CITY OF TAYLOR, TEXAS

PLANNING AND ZONING COMMISSION MEETING

July 14, 2020, 6:00 P.M.

City of Taylor
Castlewood Subdivision Improvement Plans
PZ-2020-1215
Staff Report

SHEET 2 OF 4

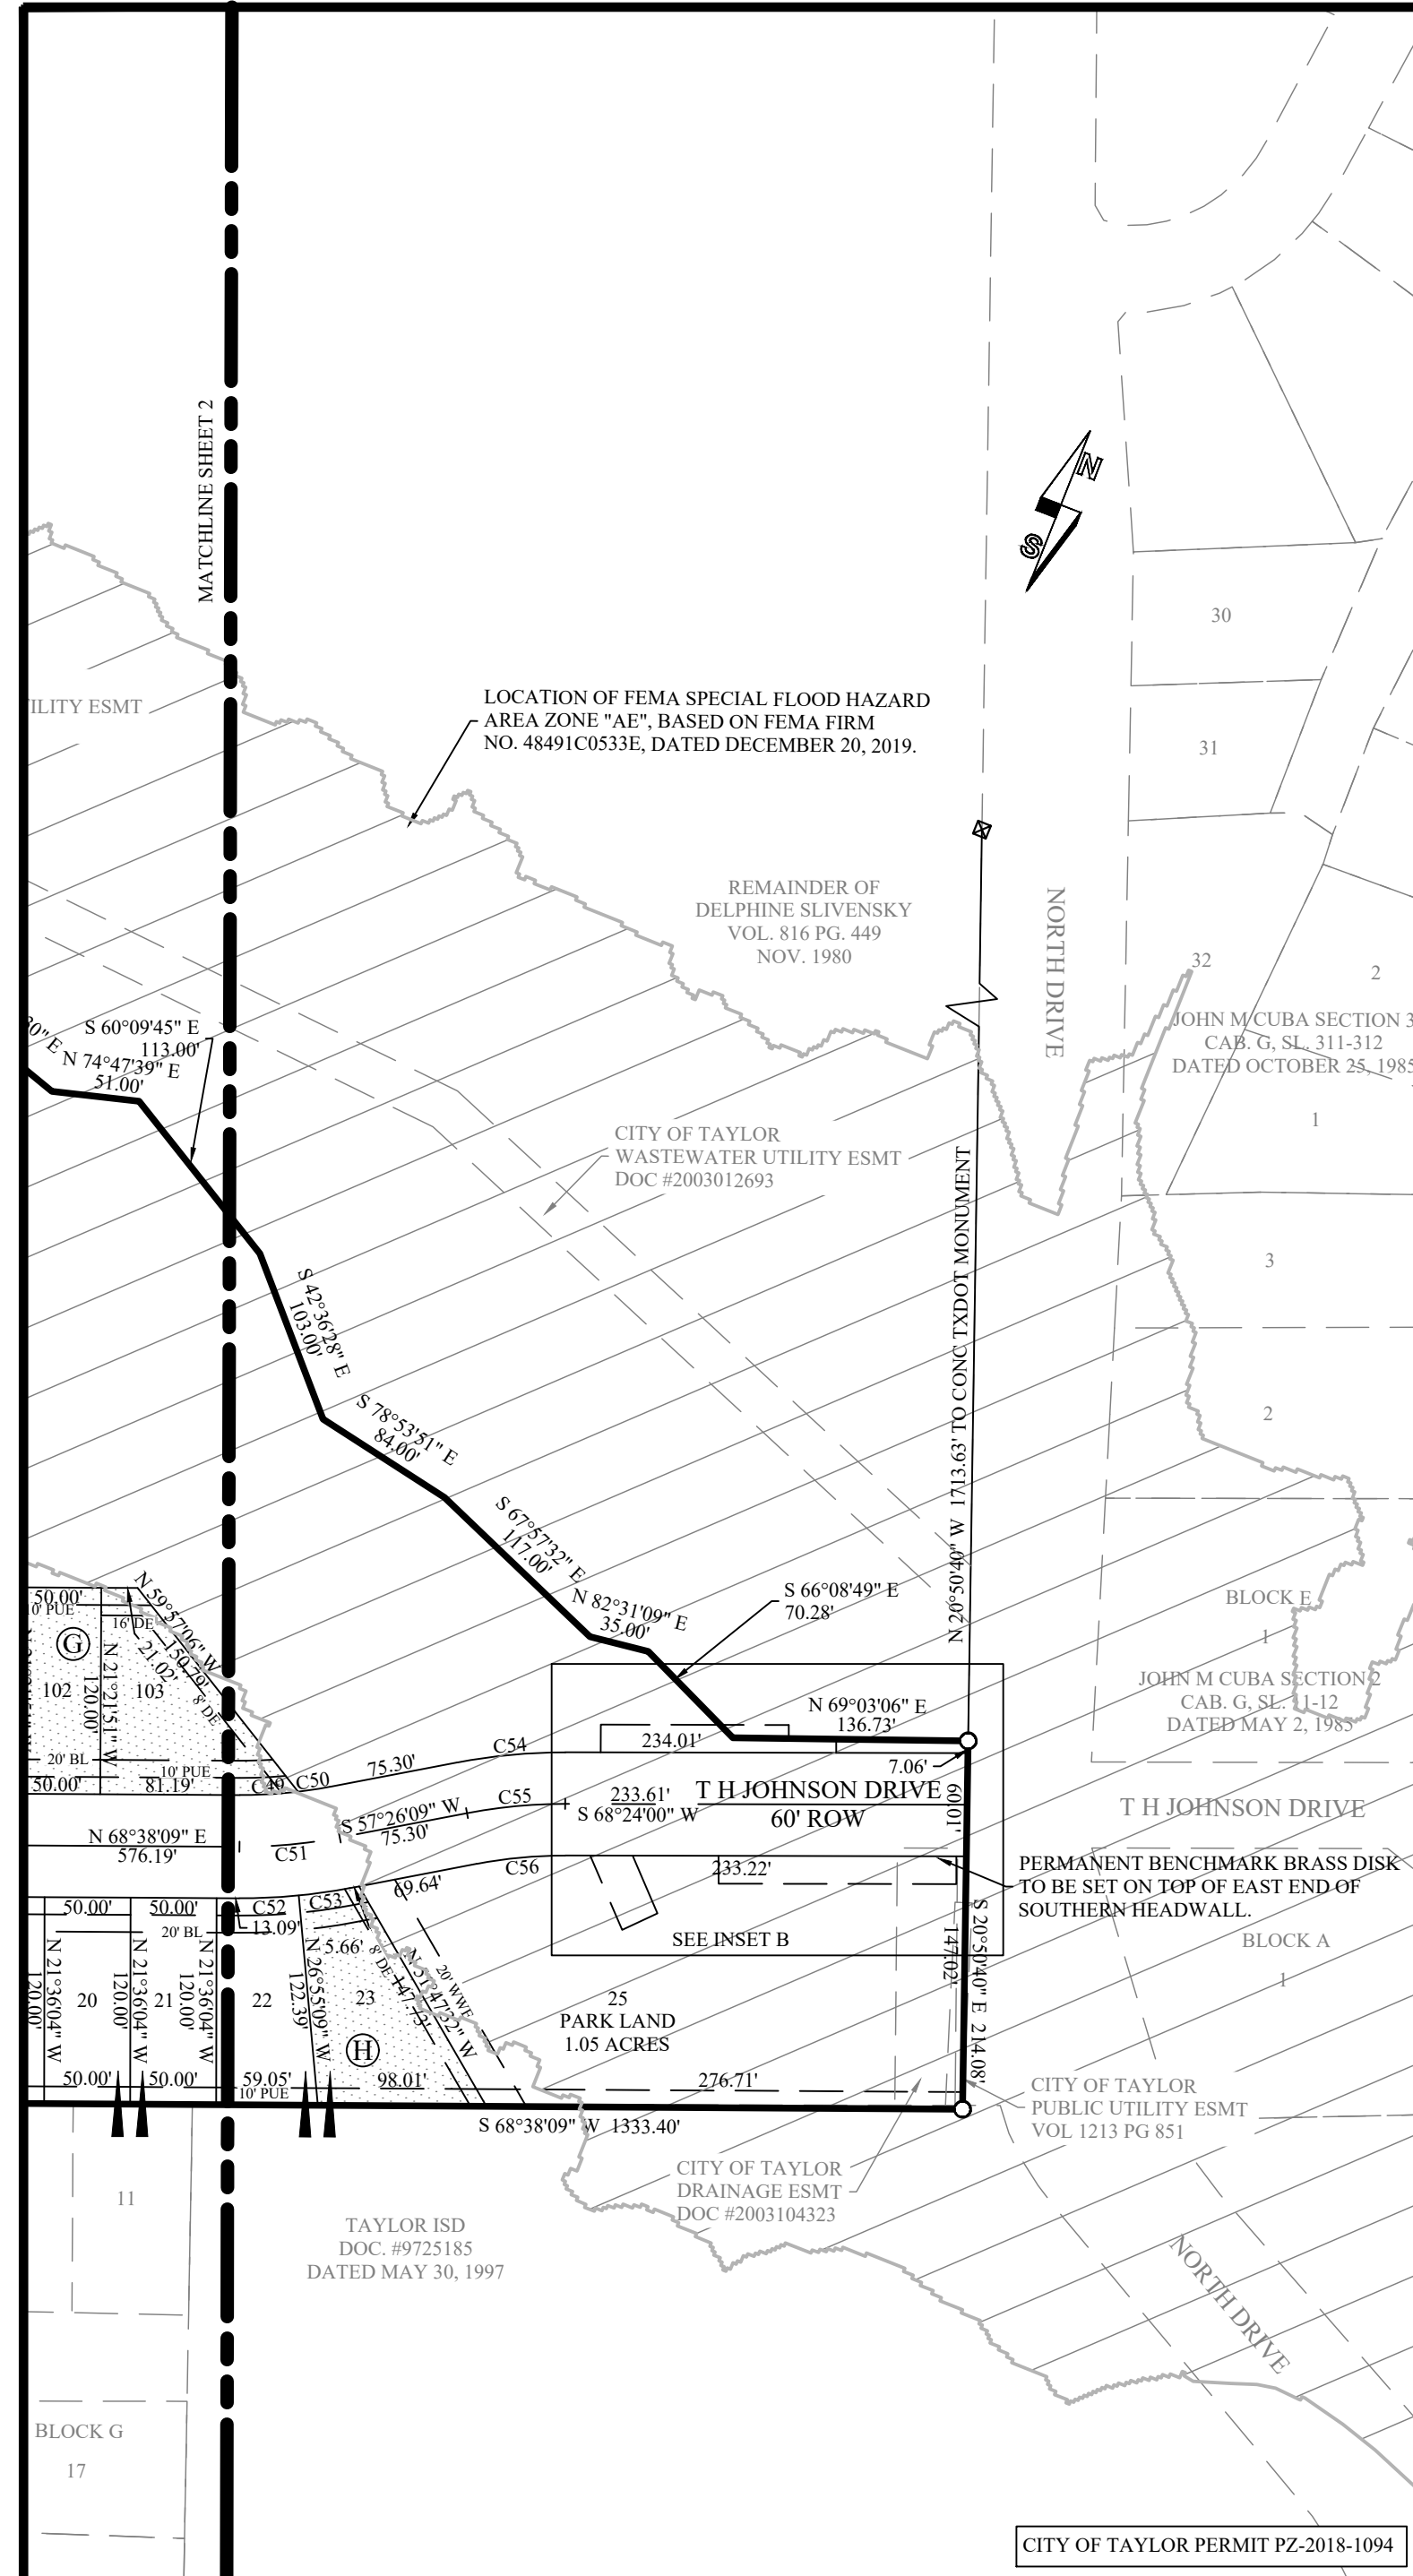
At the top of Sheet 2 of 4, there is a date January 14, 2019 that is cut in half and the remainder of the note that denotes the recorded instrument for a drainage easement is missing. Relocate the note so it is legible.

OWNER INFORMATION
WEINRITTER REALTY LP
PO BOX 782129
SAN ANTONIO, TX 78278-2129

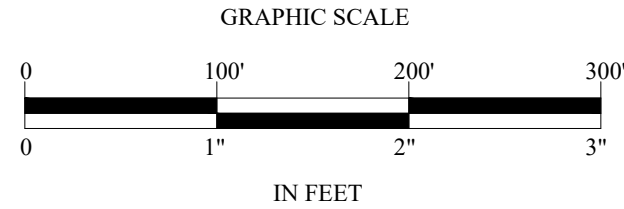
B. The owner information on Sheet 1 has Weinritter listed but I don't think any of Phase II is still owned by Weinritter.
